SERVICE NOTE

AFFECTED: STAR TREK™

NUMBER: 006

In the advent that you are experiencing difficulty controlling the volume of your game, we recommend that you exchange the existing 10K potentiometer in the Volume Control Block Assembly (Drawing No. 800-3282), page 69 of your STAR TREK™ Owner's Manual (P/N 420-0855), for a 100 ohm pot. (P/N 475-0052-00), and make the following corrections to page 68 of your Owner's Manual:

The STAR TREK™ - Cockpit Owner's Manual (P/N 420-0972) shows the red and brown colors transposed on the Control Block Assembly (Drawing Number 800-0454). Please correct your Manual on page 74:

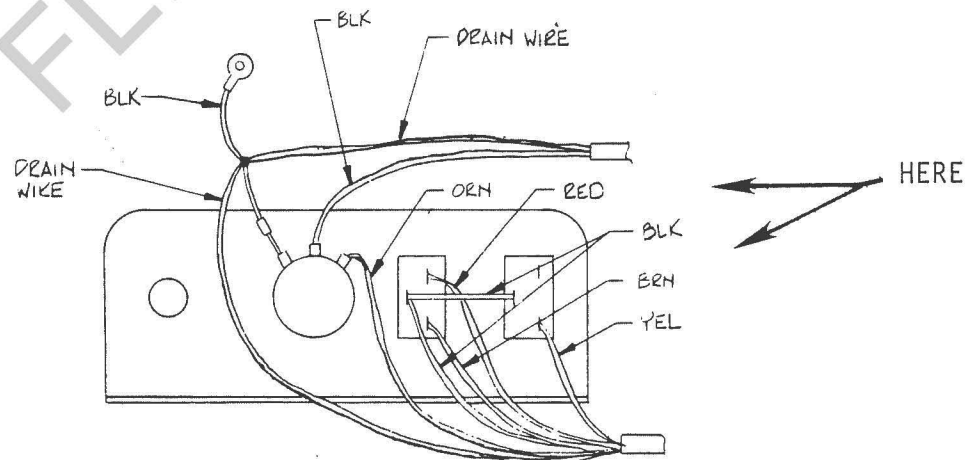
WAS:

IS:

COMPONENT SHELF ASSEMBLY

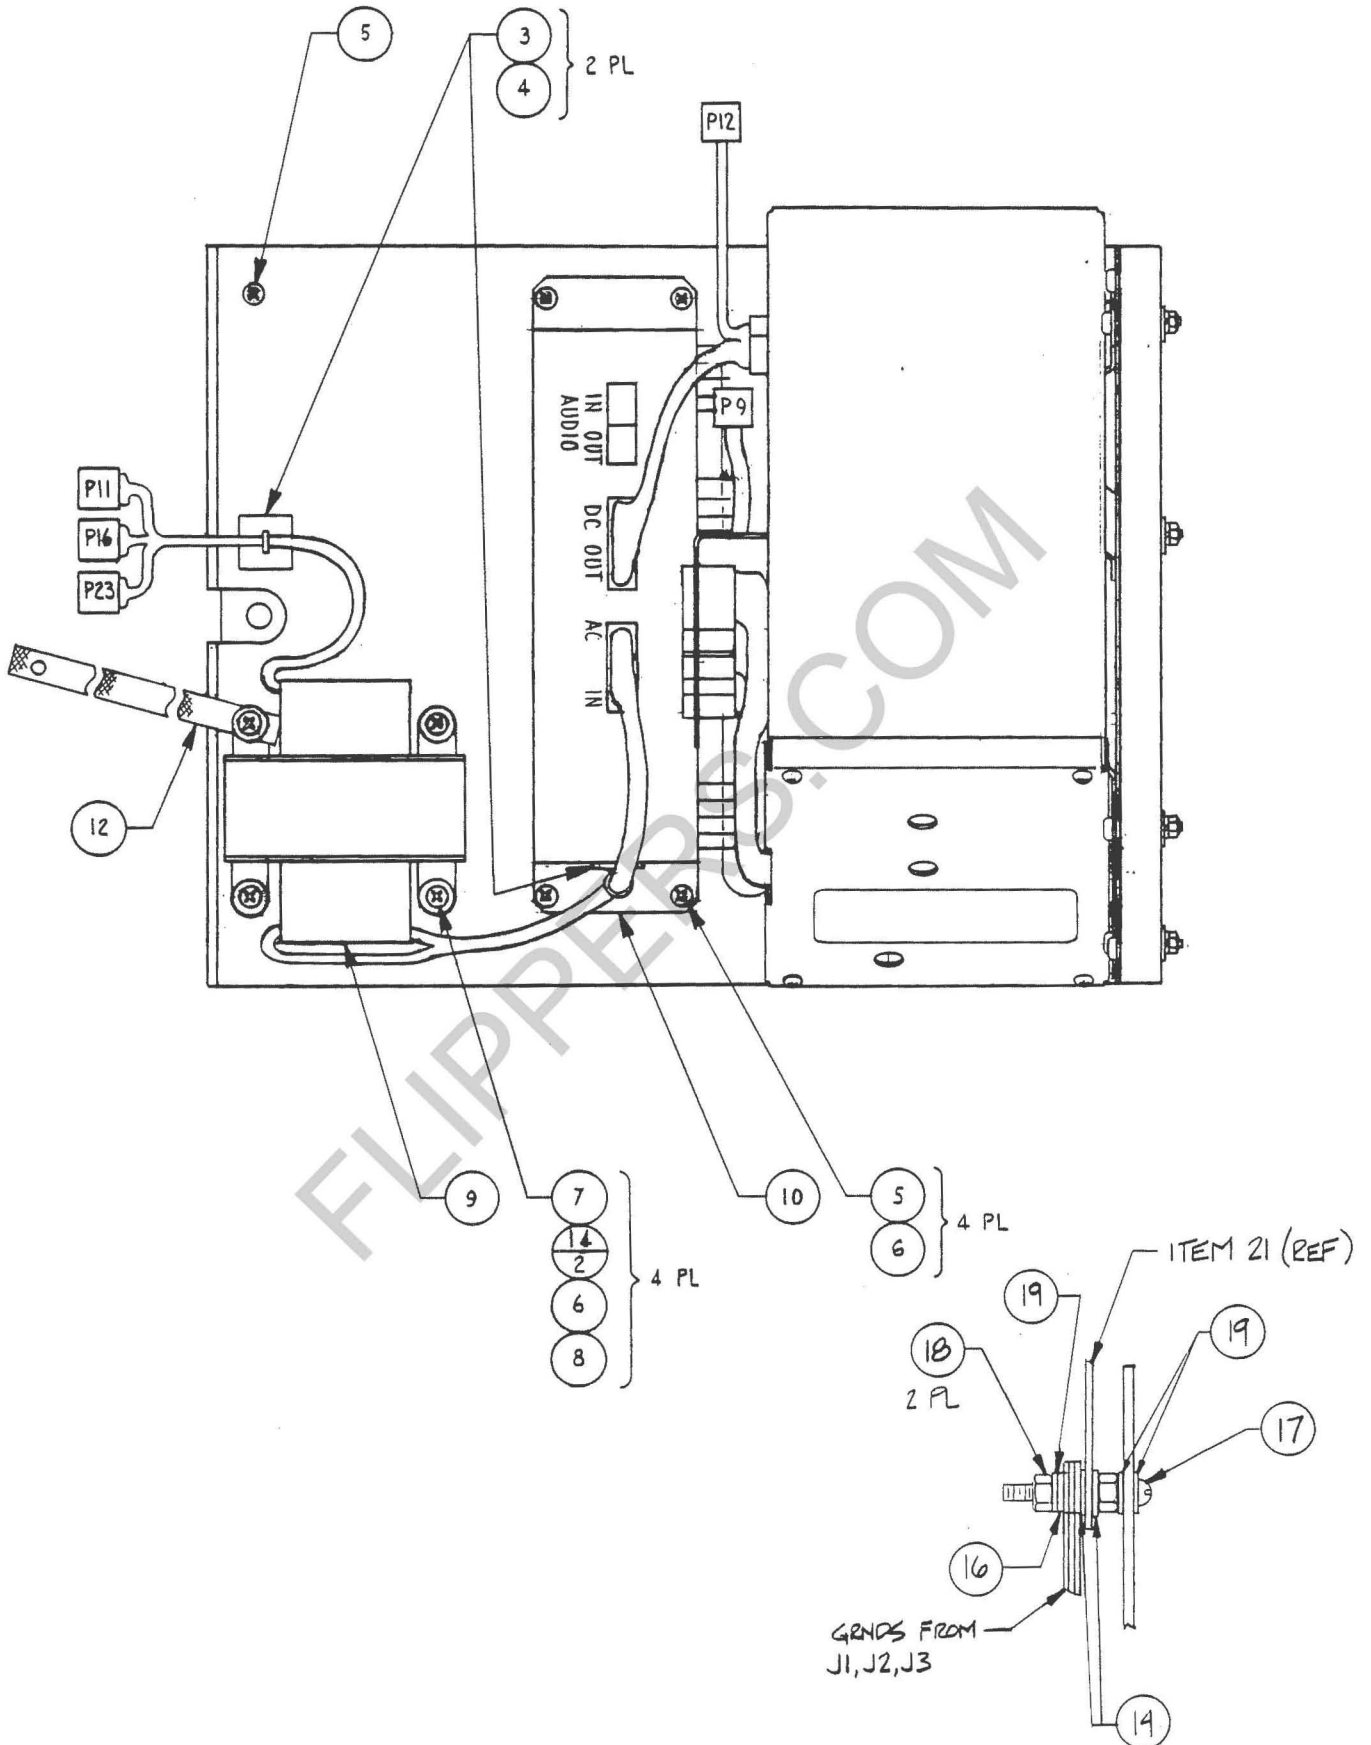
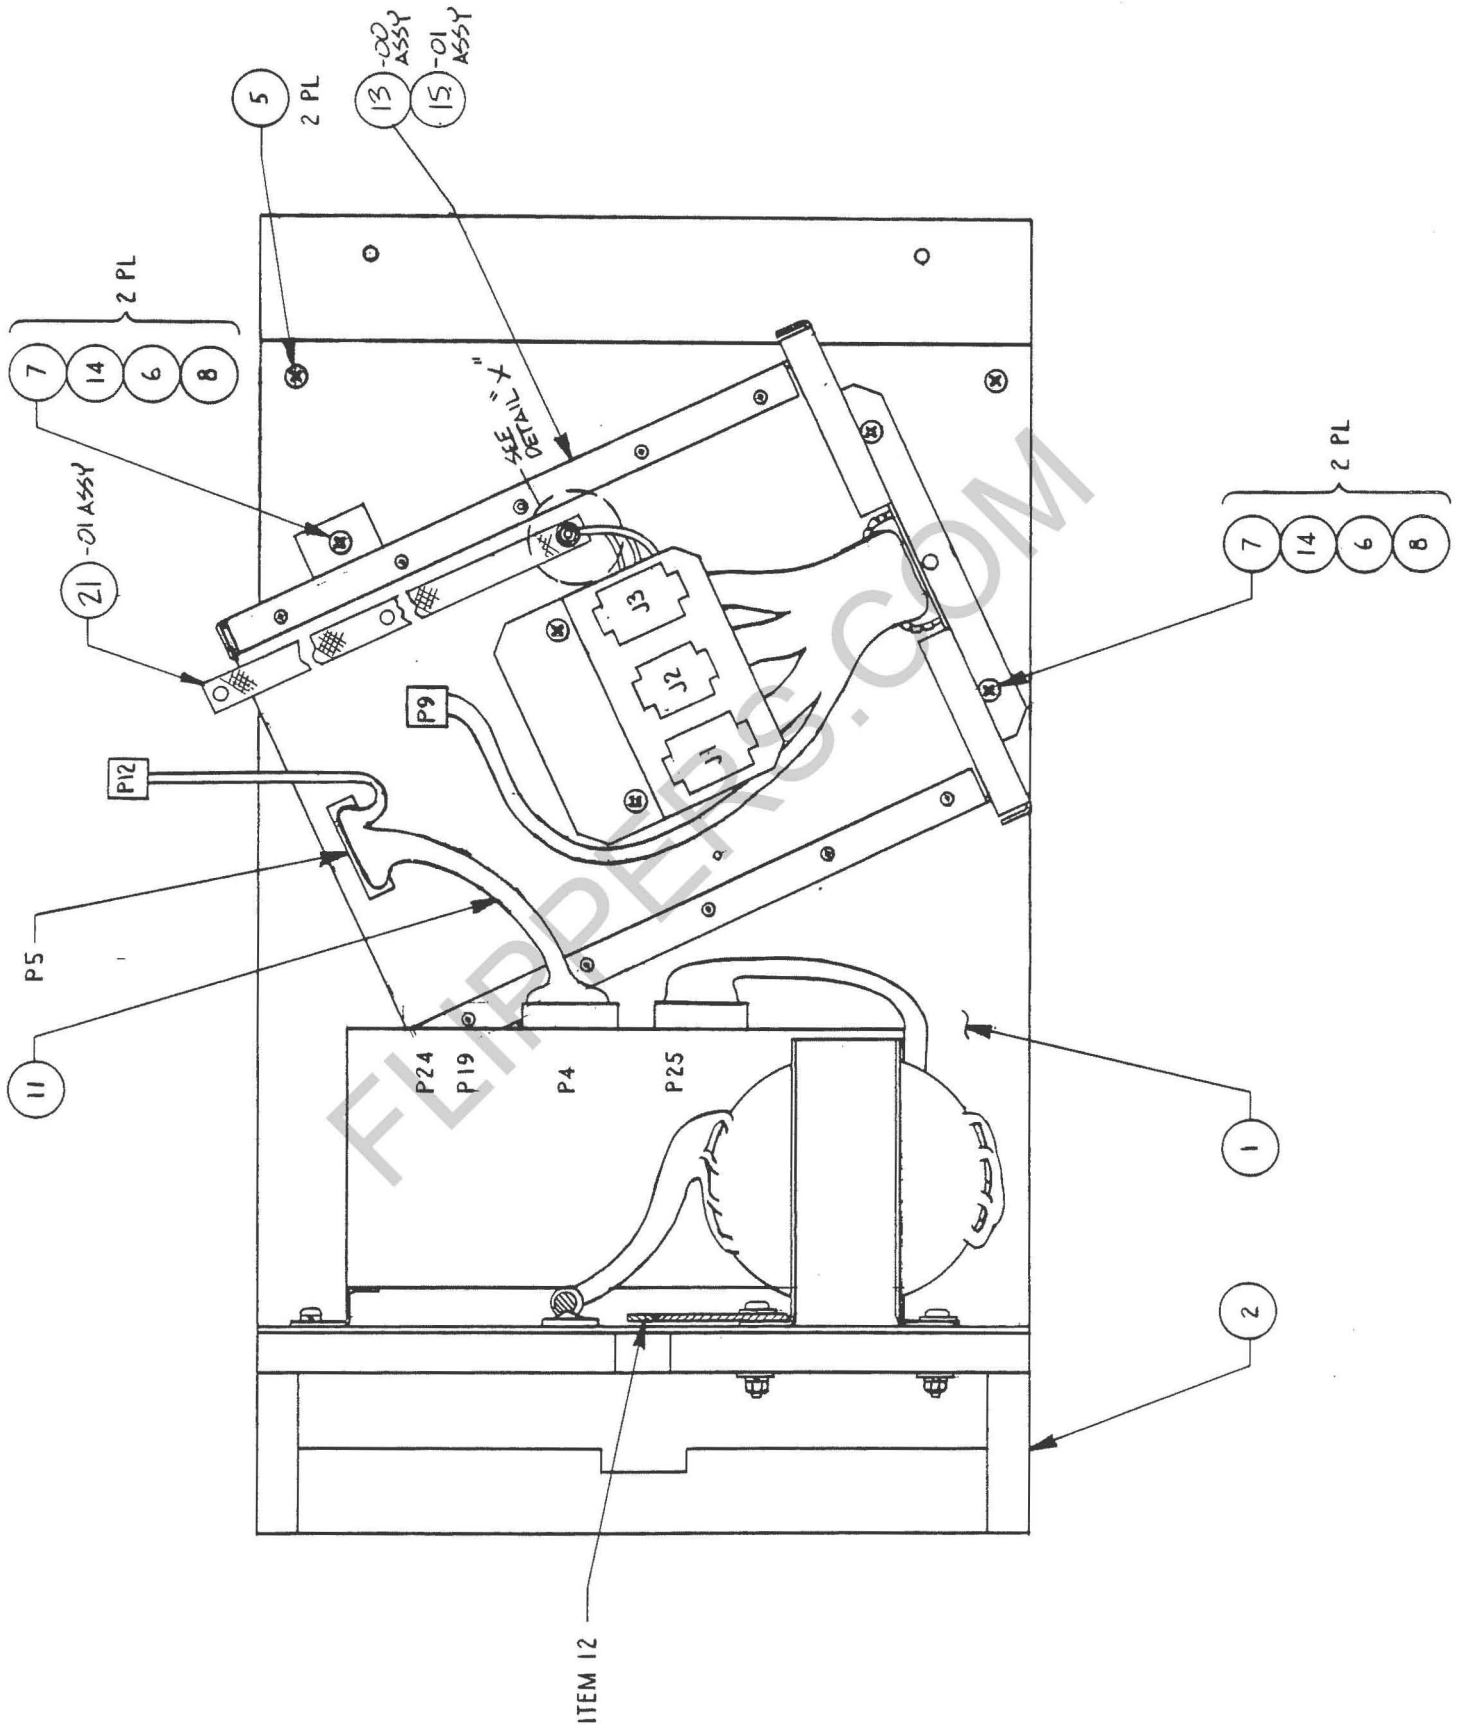
In order to fully document the FCC approved version of the Component Shelf Assembly (P/N 800-3304) with which all 700-0109 Top Assemblies are equipped, please replace pages 96, 97 and 98 in your STAR TREK™ Owner's Manual (P/N 420-0855) with the following pages:

An error has been found in the illustration for the Switch Assembly (Drawing Number 800-0444), page 78 of your STAR TREK™- Cockpit Owner's Manual (P/N 420-0972). Please make the following correction to your Manual:

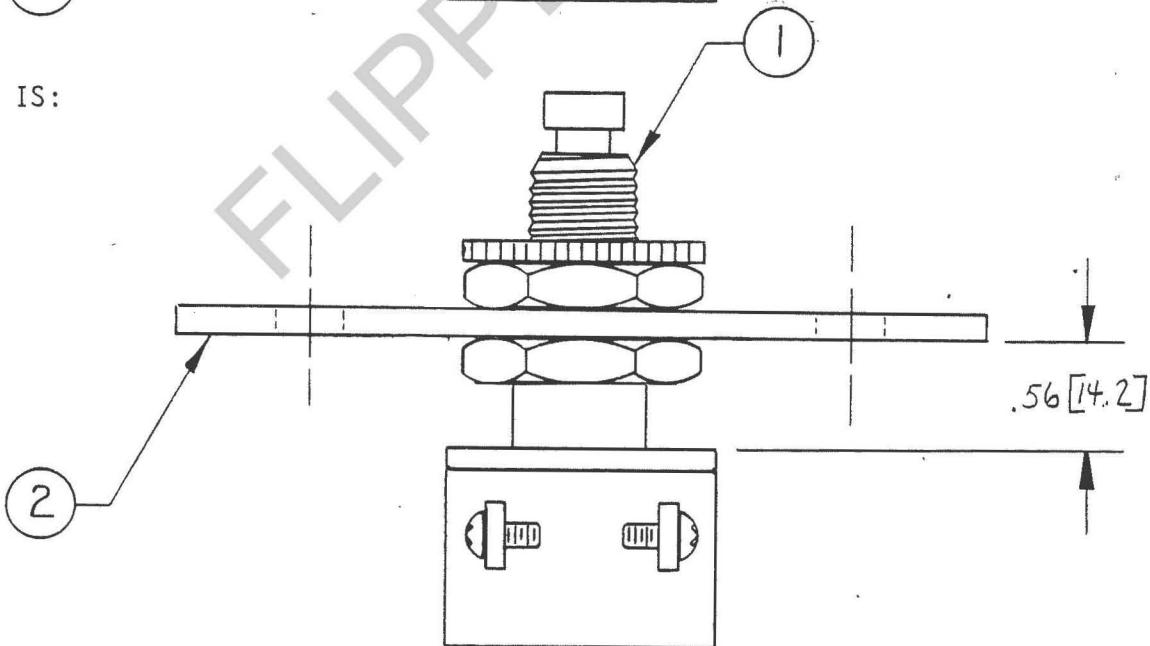
WAS:

IS:
